Access Compliance Report Public Rights-of-Way (Curb Ramps)

Main Street: IRVINE_AVE Cross Street: LA_CANADA_WAY Location: W

ADA ID: RPRK211018120304 Ramp Type: Type 4 - Parallel Initial Pass/Fail: Pass Overall Compliance: No Severity Score: 0

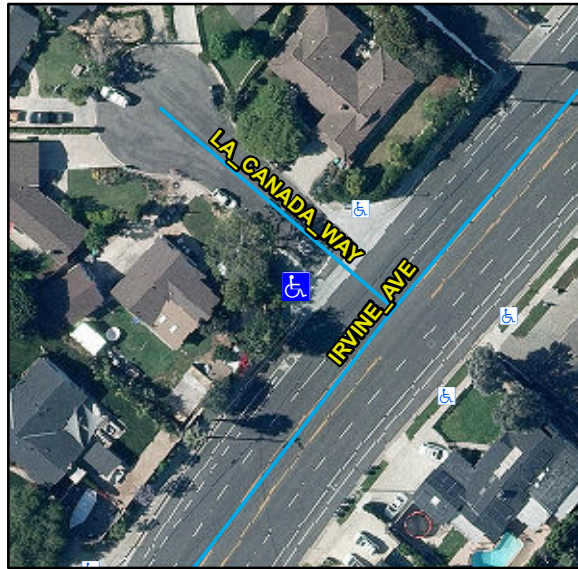
N/A	Ramp Inside Crosswalk 1	N/A	N/A	Ramp Inside Crosswalk 2	N/A
	Crossing 1 Slope (%)	2.5		Crossing 2 Slope (%)	1.3
	Crossing 1 Cross Slope (%)	2.2		Crossing 2 Cross Slope (%)	1.8
Yes	Gutter Ponding	No	No	Curb Slope	10.8
Yes	Gutter Lip Height (in)	0		Road Run Slope (%)	0.4
Yes	Gutter Run Slope (%)	3		Road Cross Slope (%)	2.1
Yes	Gutter Cross Slope (%)	0.9	Yes	Perpendicular Joint Present	Yes
Yes	Overall Surface Condition	Acceptable			
	Cross Gutter Present?	Yes		Spandrel Present?	Yes
	Replace Cross Gutter?	No		Replace Spandrel?	No

Remove & Replace Curb Slope.
